Deadline 6 Submission on Behalf of the Neighbours and Users of Queen Elizabeth Park

Nick Jarman

Interested Party reference no: **20022545**

Rough diagram of Farnborough Hill sports facilities, drawn by a current pupil

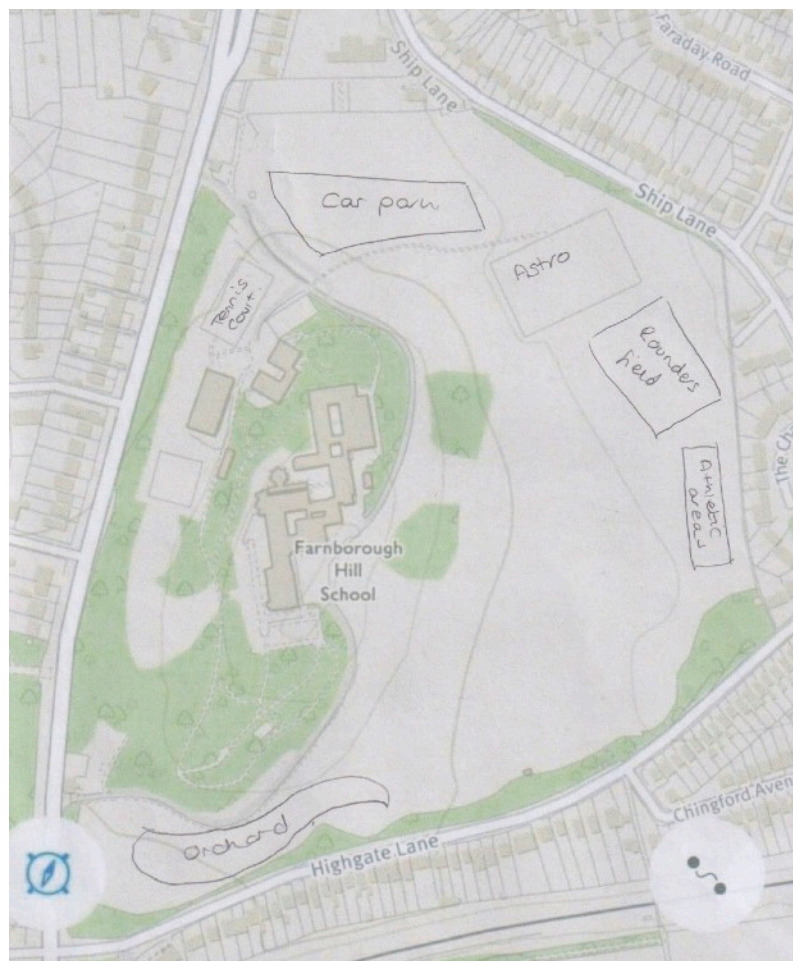
Outdoor sports facilities at Farnborough Hill are in the northern and eastern areas of the grounds, as shown on the map below. The annotations were drawn by a current pupil at the school.

Assuming a shortened HDD bore where the stringing area can be completely accommodated in the school grounds, the pipe string might intersect with the athletics area, however the same is true of narrow working area NW18, which runs through the same space.

B2325300-JAC-000-ENV-DRG-111139

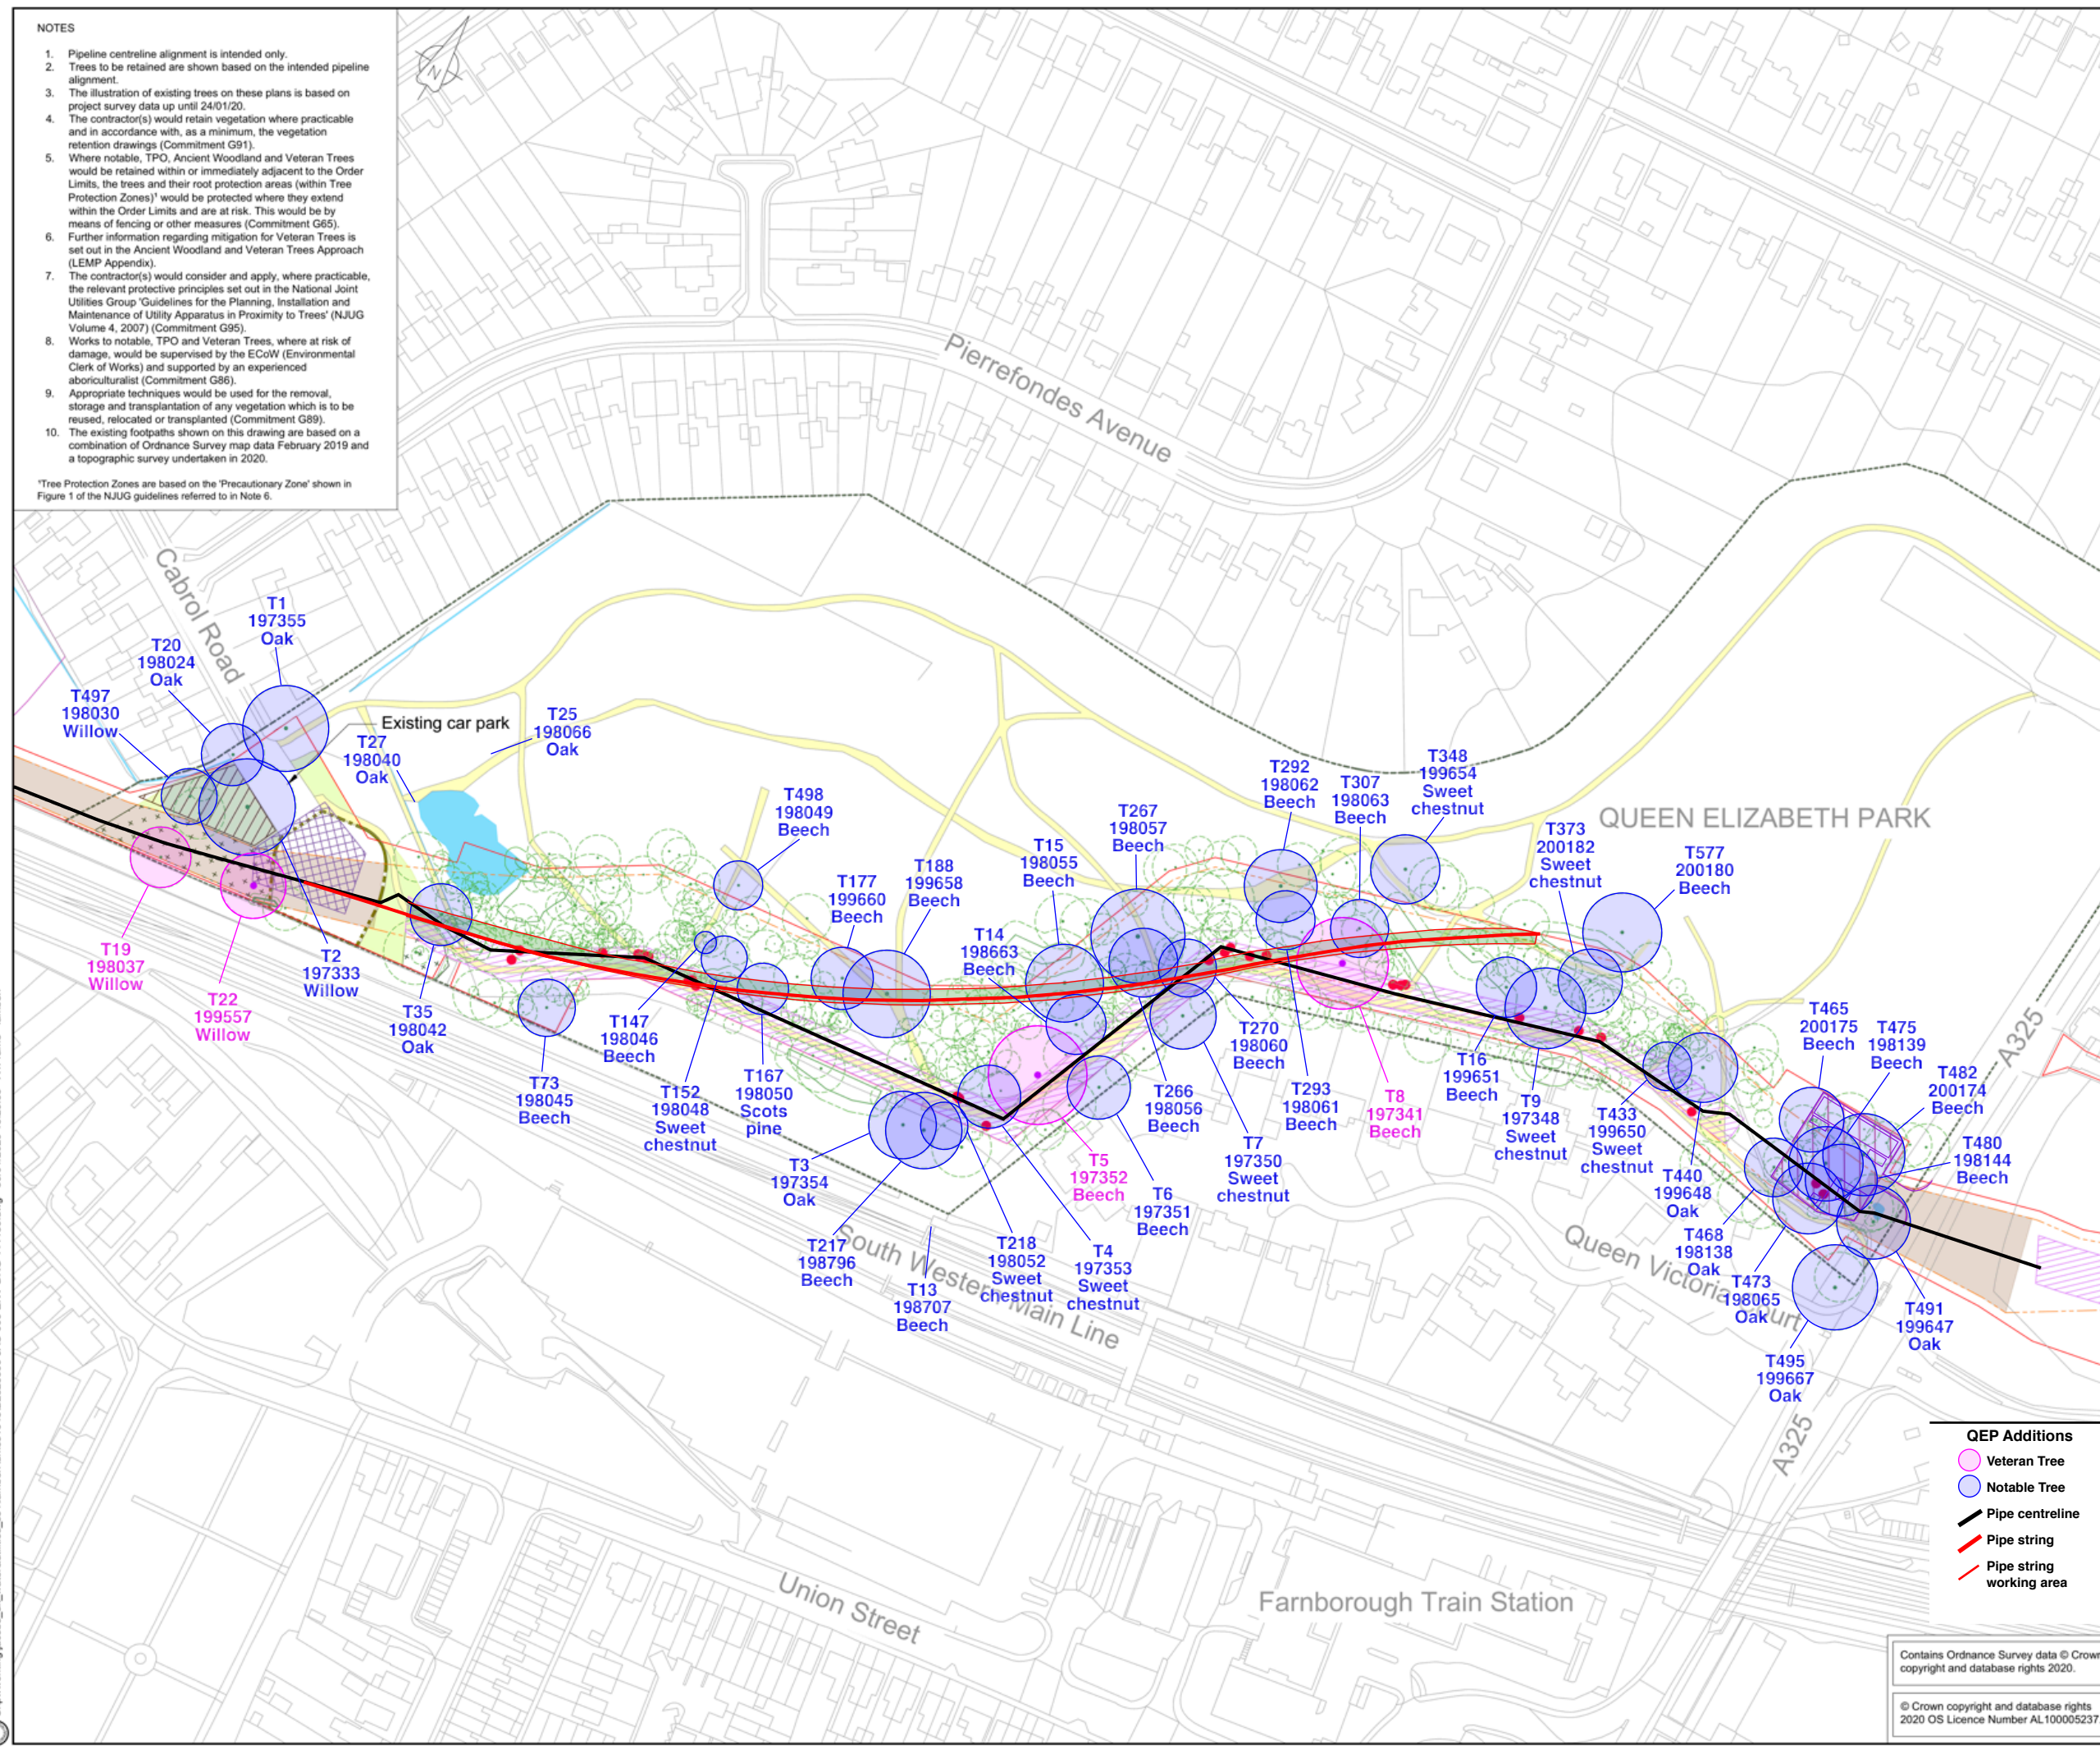
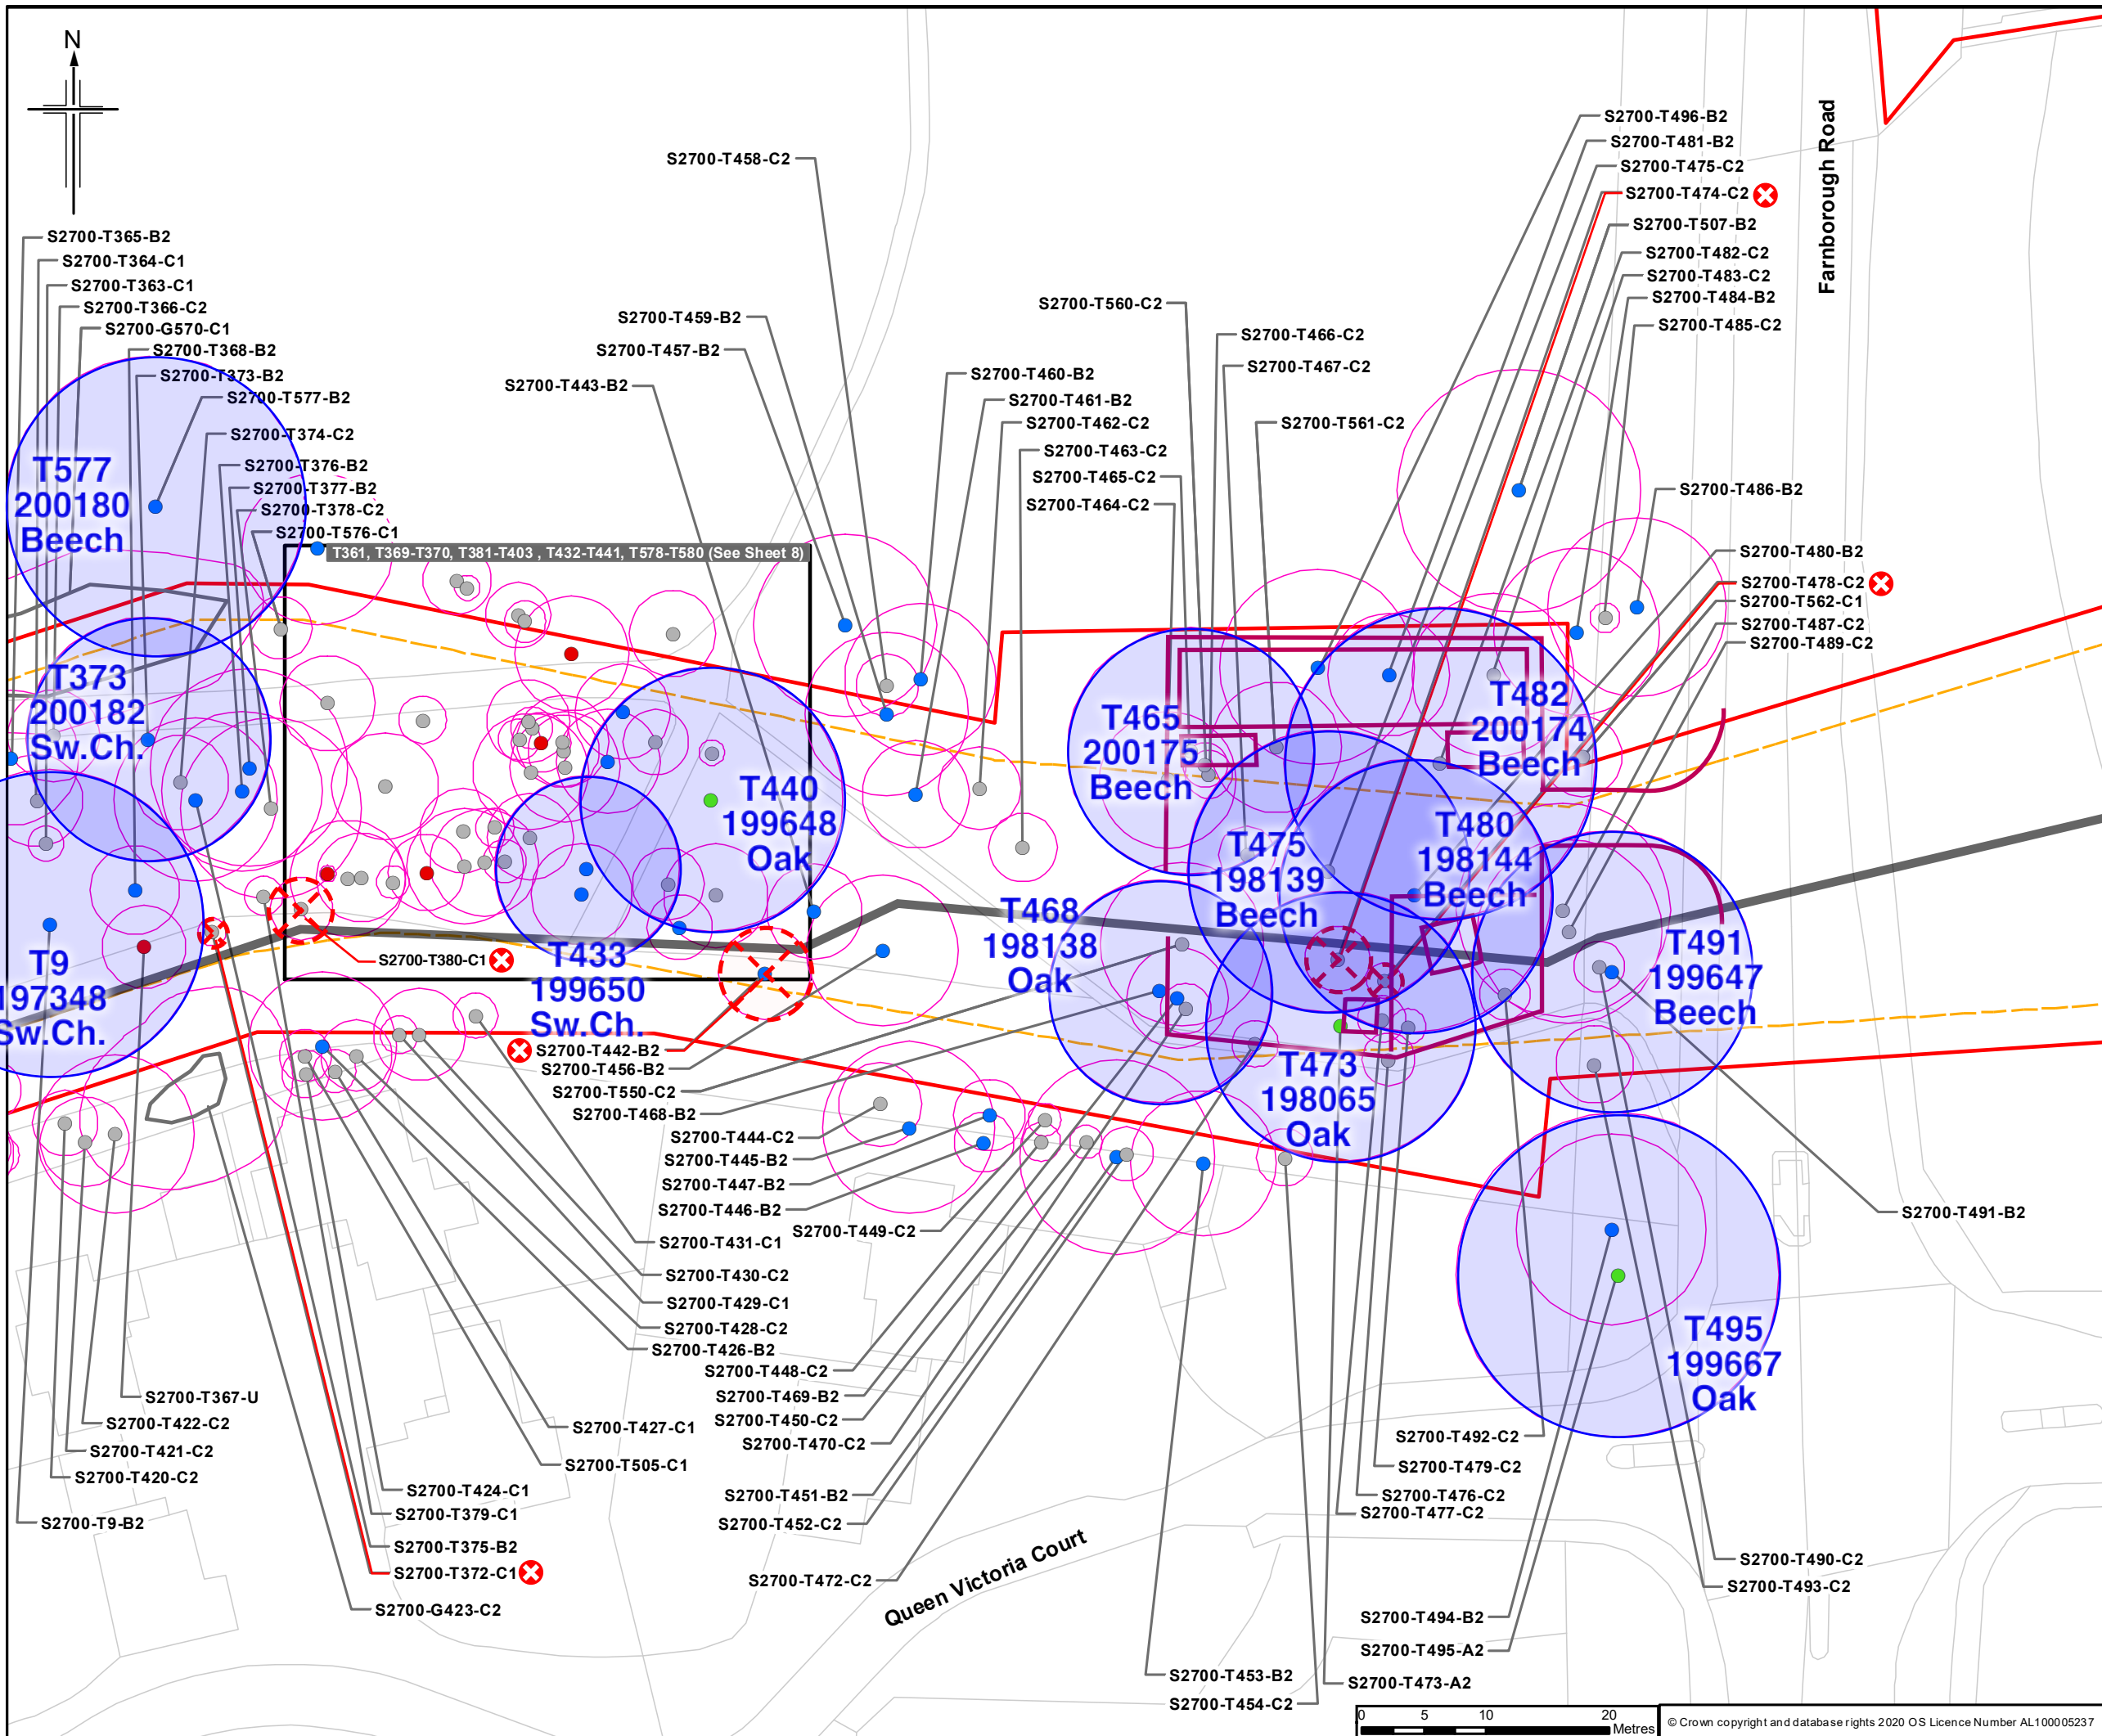
We have continued to classify trees in the park since the previous deadline. As a result the Woodland Trust has added four more Notable Trees which are within the Order Limits to the Ancient Tree Inventory.
